Village of Itasca

Committee of the Whole Meeting Agenda June 21, 2016

TO: Village President Jeff Pruyn and Itasca Board of Trustees
FROM: Nancy Hill, Community Development Director
DATE: June 16, 2016 for June 21, 2016 Village Board COW Meeting
RE: Relief from Building Code for 400 E. Walnut Street (Itasca County Club)

Subject: Village of Itasca/Illinois Tollway/IDOT/DuPage County/Township of Addison
Intergovernmental Agreement (IGA)
Illinois Route 390 Hamilton Lakes Drive to Arlington Heights Road
Recommendation for Execution of Cost Participation Letter (with conditions)

CONTRACT NO. I-13-4629
 LANDSCAPING AND FENCING PLANS

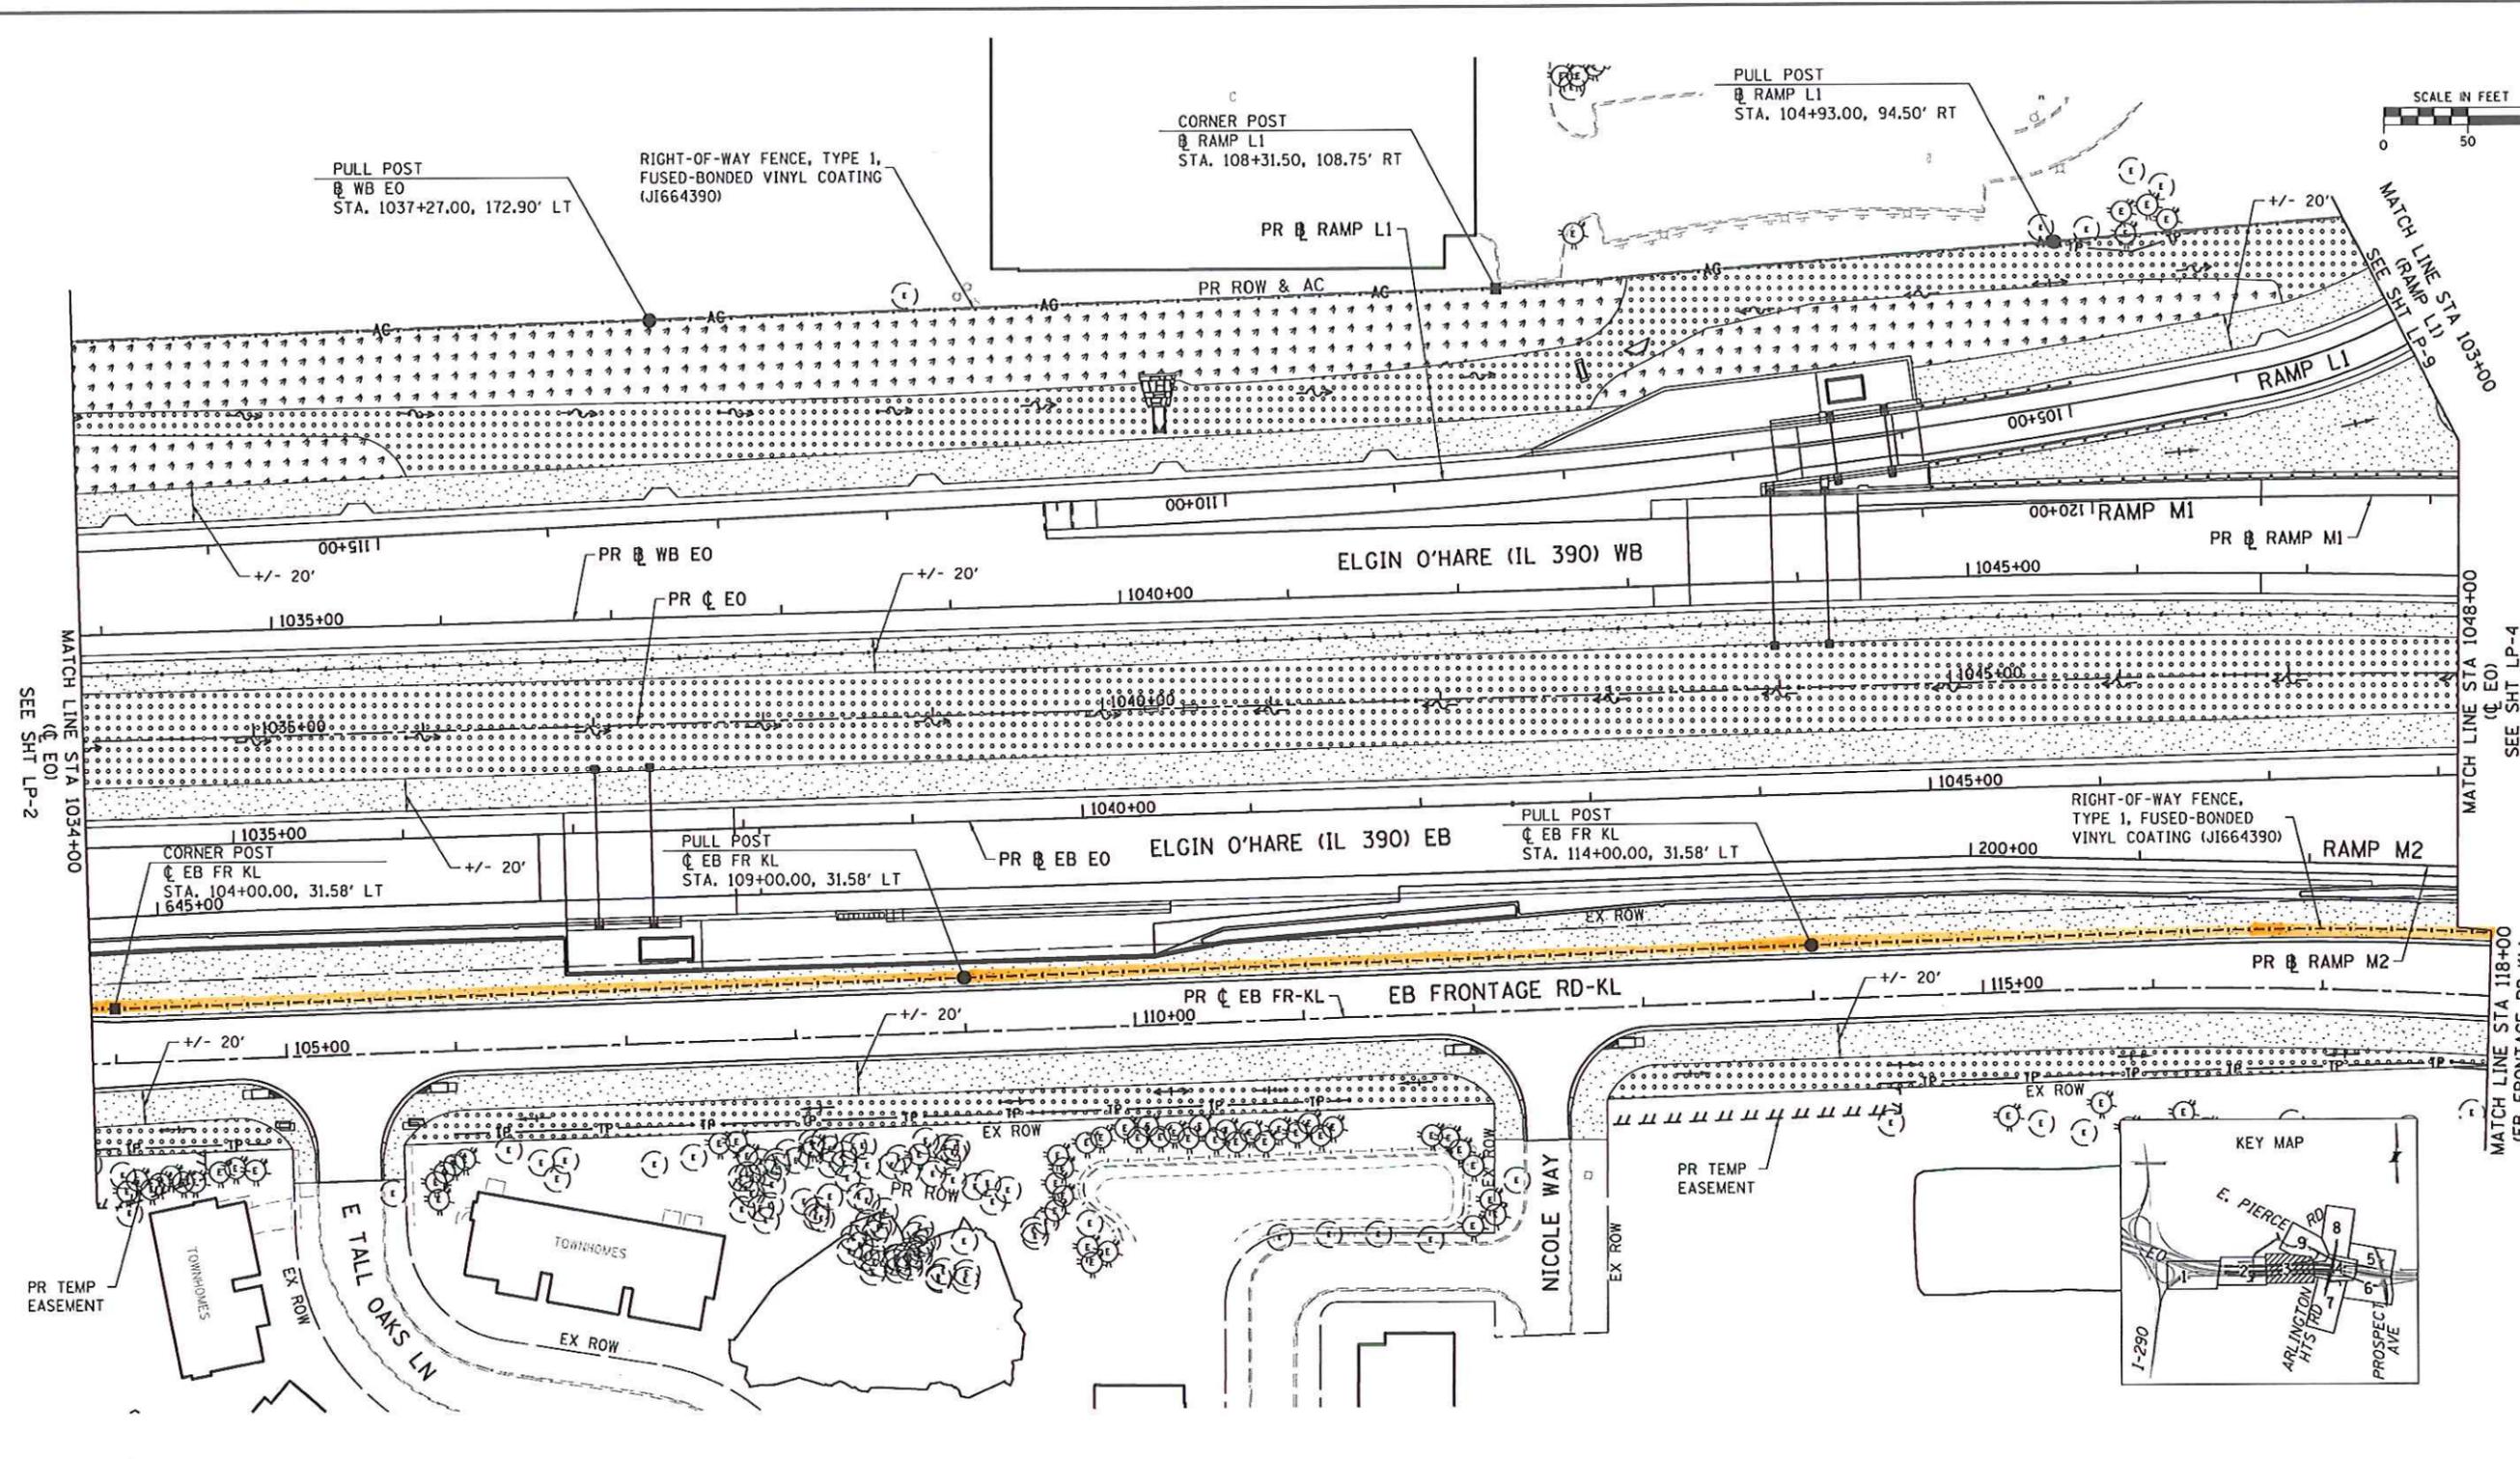
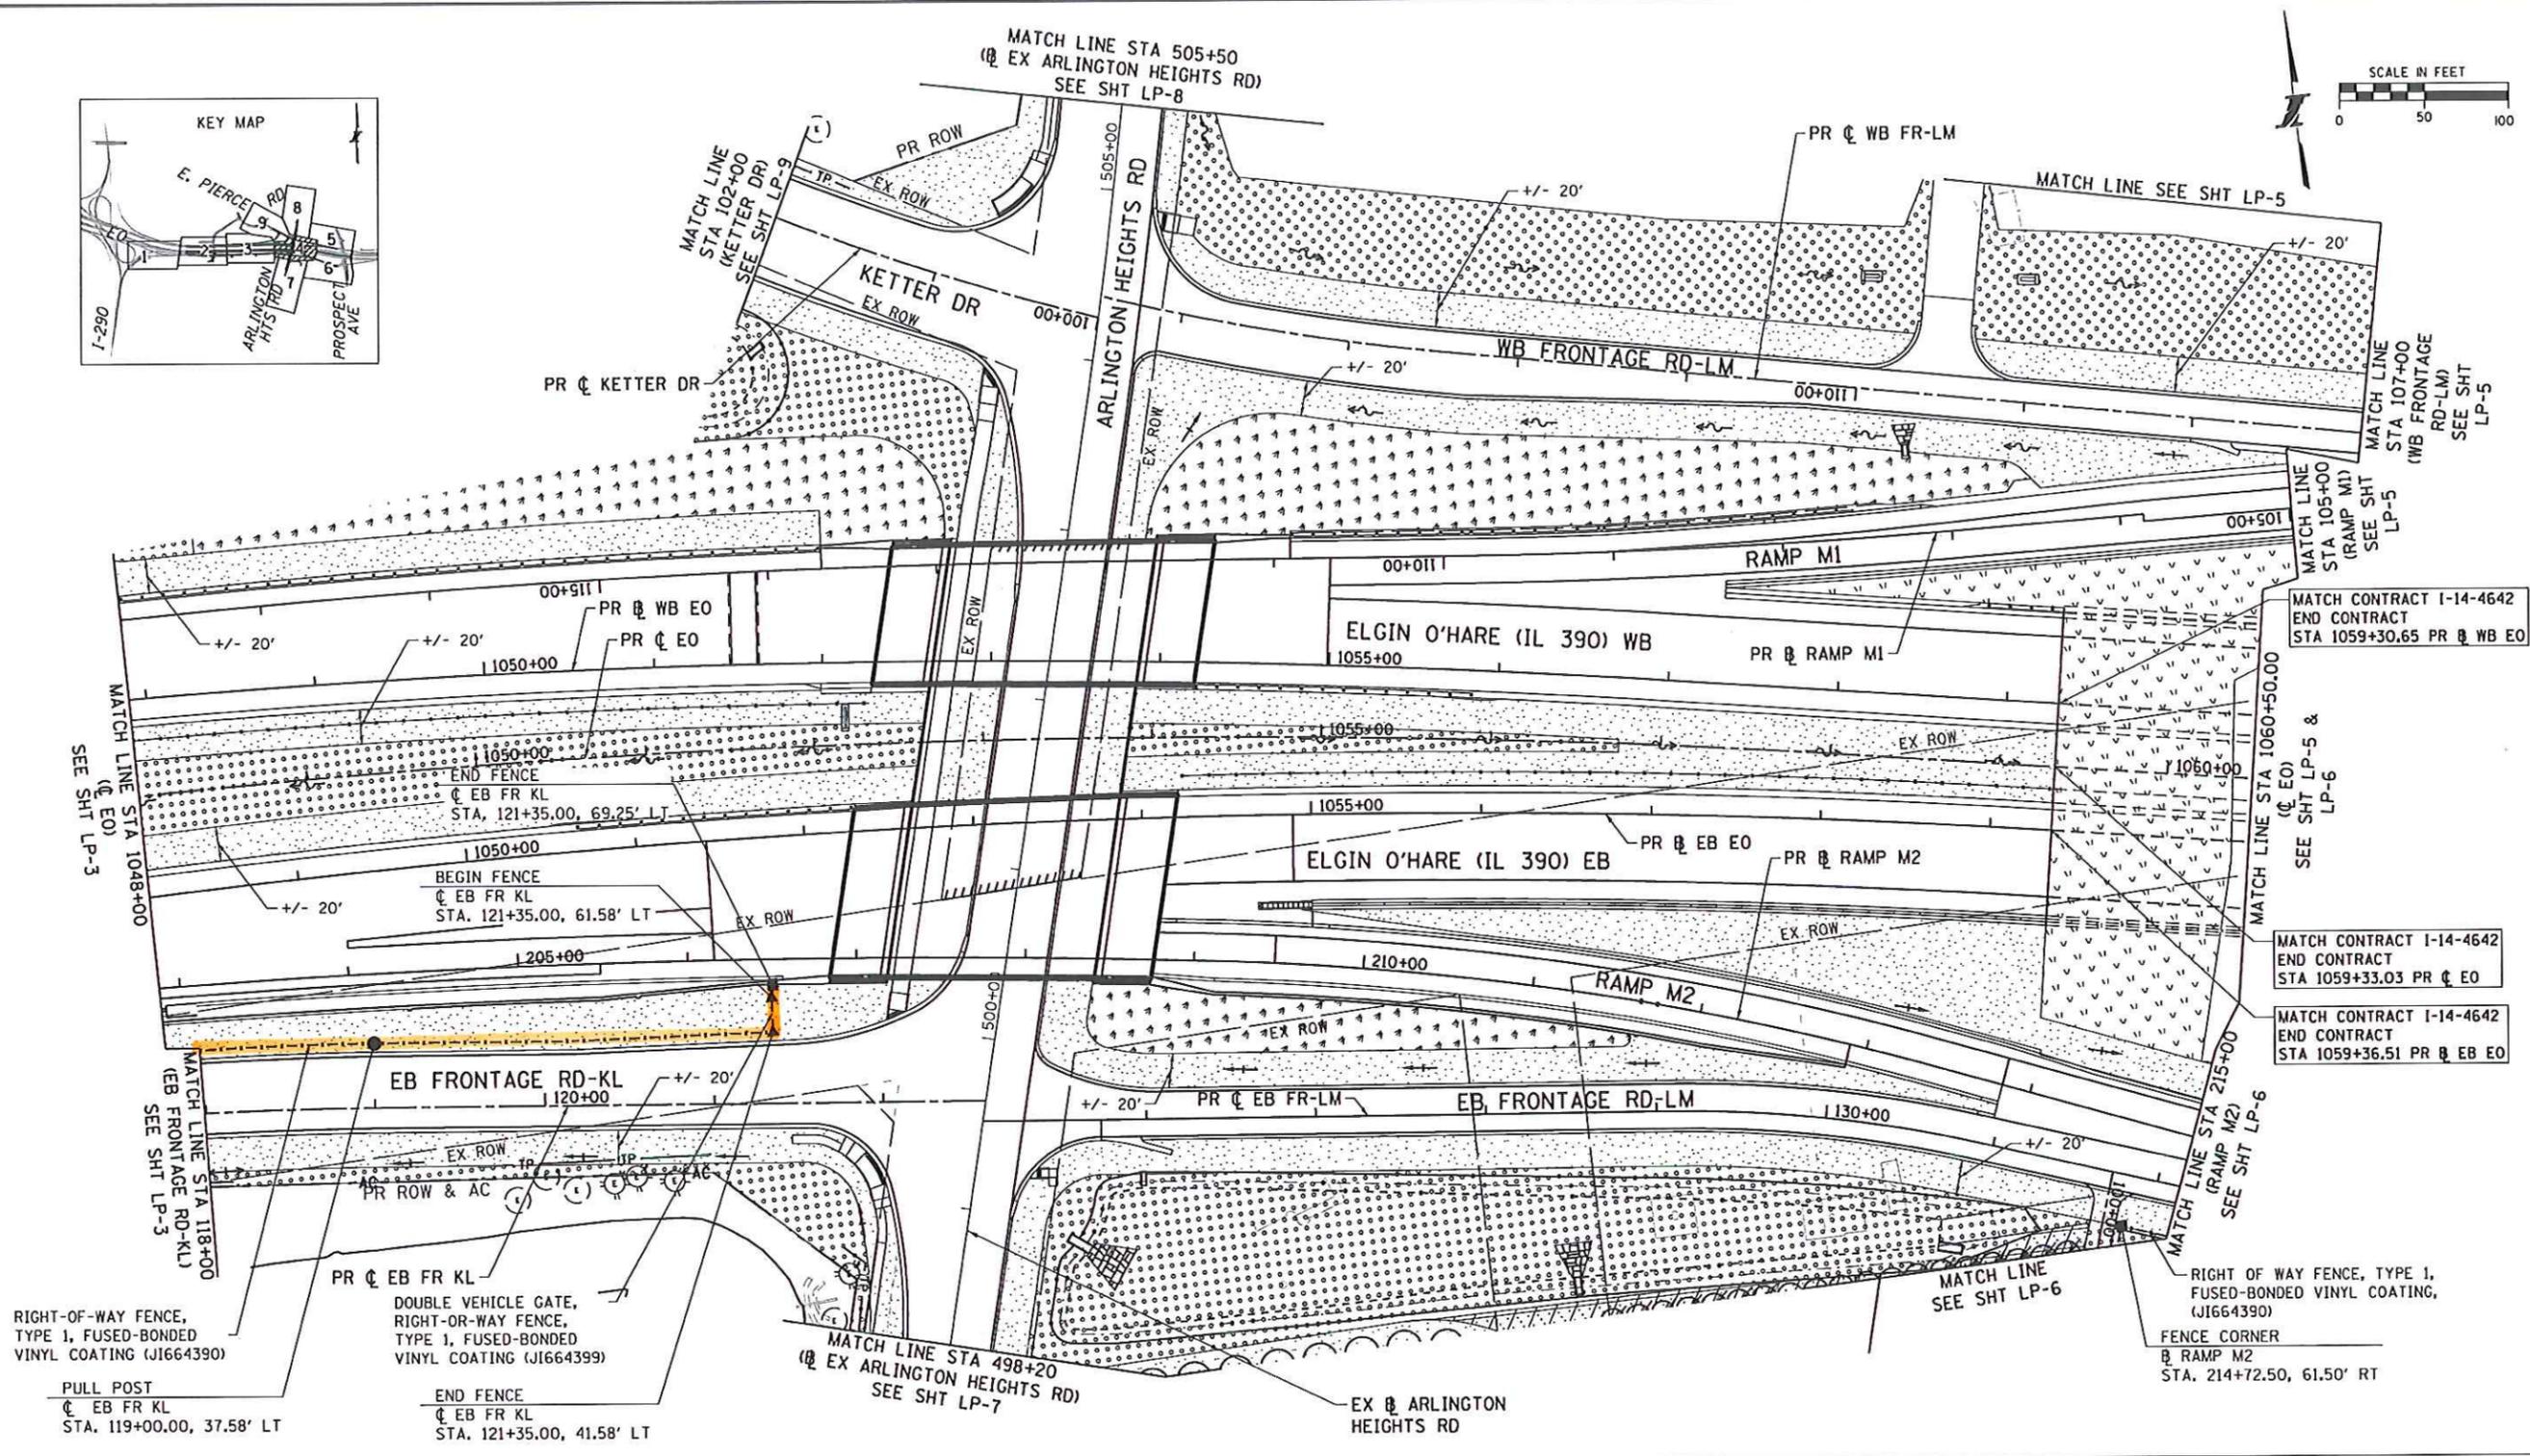
We are in agreement with the items and terms contained within the letter, with the exception of the limits and location of the access control fence along the South Frontage Road.

The current design plans include access control fencing between the EB Illinois Route 390 and the South Frontage Road, between Hamilton Lakes Drive and Arlington Heights Road, for a distance of about 2100 feet. This fencing is parallel to the South Frontage Road and is located about 6 feet from the north curb and gutter, and is desired by the Tollway so that their buried ITS fiber optic communications cables and conduits are located within a secured area. Along with the buried ITS conduits are 5 handholes that are constructed flush with the ground surface, which provide access to the ITS system cables.

- The location of this access control fence, as shown on the attached design sheets highlighted in orange, will severely restrict the ability of the Village to request landscaping enhancements in the parkway area between Illinois Route 390 and the South Frontage Road, severely limiting potential aesthetic improvements to this area which will be a key entry route to the Village.

- I have attached additional design drawings with suggested alternative access control fence segments highlighted in green, which will still provide security for the ITS handholes located in this parkway area. With only five handholes in a 2100 foot distance, this seems to be a viable alternative to provide security for the ITS system while not disrupting the potential landscaping enhancements which could be placed along this route.

- **I recommend that the Village Board consider providing direction to the Mayor to submit a request letter (which I will have drafted by the COW Meeting) to the Illinois Tollway requesting their redesign of the access control fence as shown in the attached exhibit.**
- **I also recommend that the Village Board consider providing direction to the Mayor to sign the attached cost participation letter which the Illinois Tollway has requested in the interim until the IGA can be finalized. This response should include comments that the Village is in agreement with all items of the request letter, except the limits and expense of the access control fencing, due to the requested redesign.**
